No. EL/3.2.19/(G)

MODIFICATION SHEET No. RDSO/2014/EL/MS/0433 Rev.'0'Dated 28.03.2014

Modification to provide 1^{1/4} ball type isolating cock in place of D-1 Emergency Brake valve in tap-changer (unmodified CAB) Electric locomotives.

10.0 MODIFICATION DRAWING :

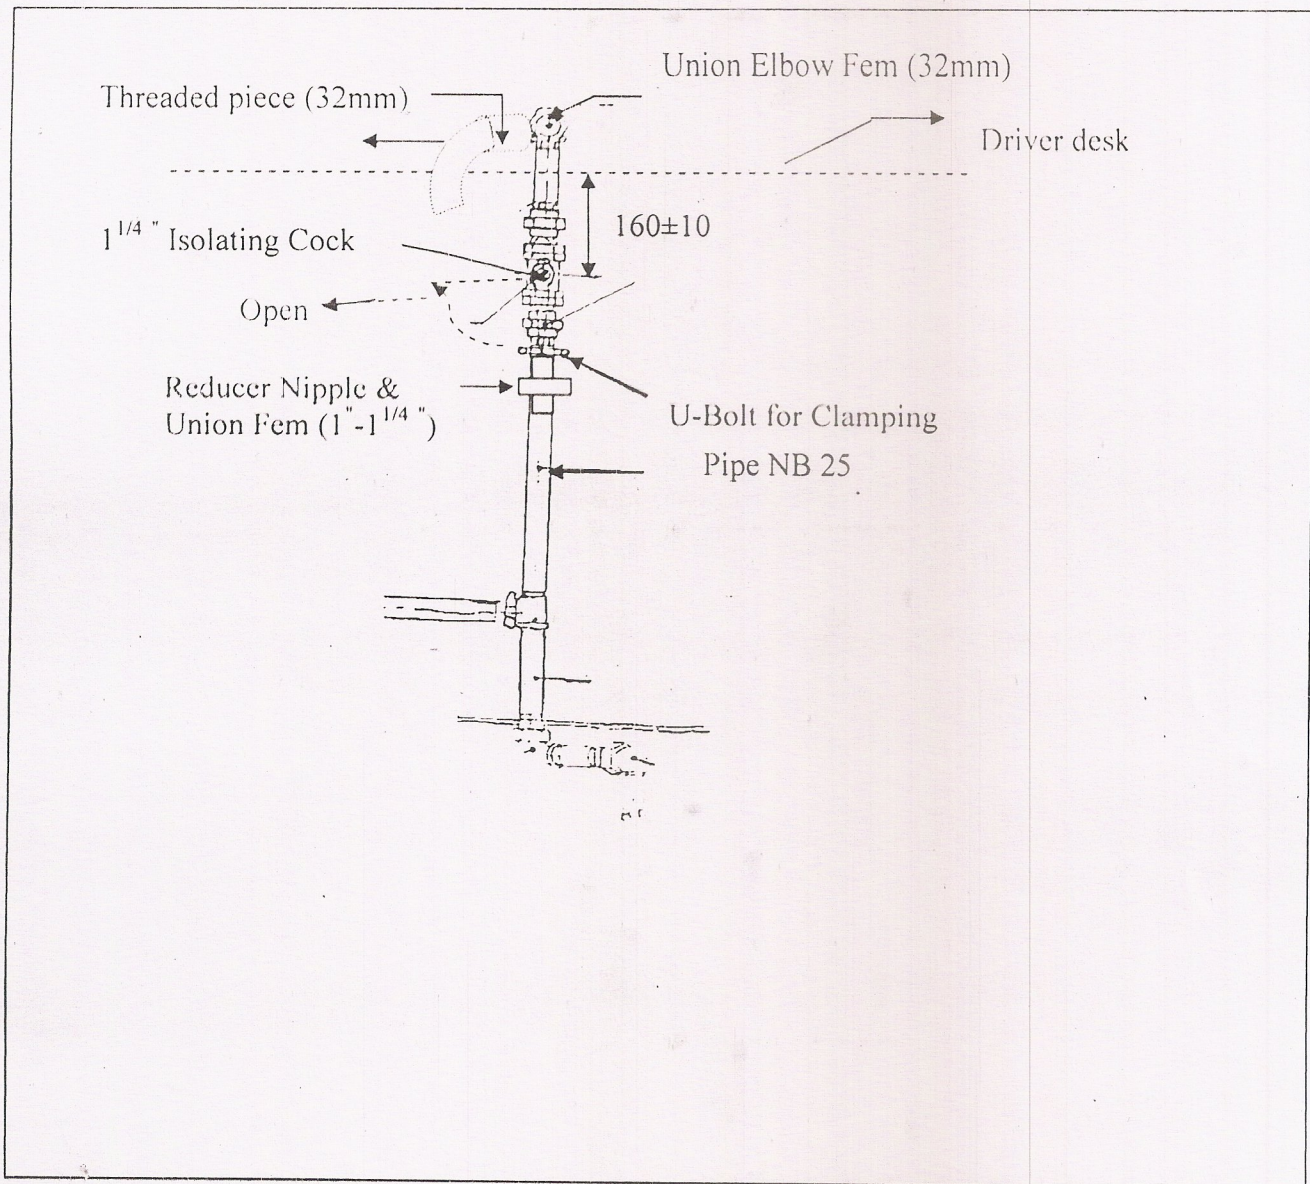
The existing D-1 emergency valve (RS) will be replaced by 1^{1/4} ball type isolating cock as per CLW Drawing No.1209-18.306-187 of 1^{1/4}” isolating cock in tap changer (Unmodified cab) Electric Locomotives.

- Modify the connecting pipe by providing 1^{1/4} ball type isolating cock as per CLW Drawing No.1209-18.306-187 for 1^{1/4}” isolating cock on the pipe at height about 160 +/- 10 mm below the driver desk with the help of union reducer nipple joints in accordance with CLW drawing no 03/0/37/53 for pipe layout of WAP-4 / WAG-7 (crew friendly) locomotive.

- Provide 01 Union Elbow joint with connector on the other end of isolating cock.
- Connect 01 threaded piece of suitable length to the elbow joint and place the open end of threaded piece inside the hole of existing D-1 emergency valve for exhausting the BP air pressure. Weld metal sheet to block the gap.

- Provide suitable clamping arrangement to provide strength & firmly support with the driver's desk.
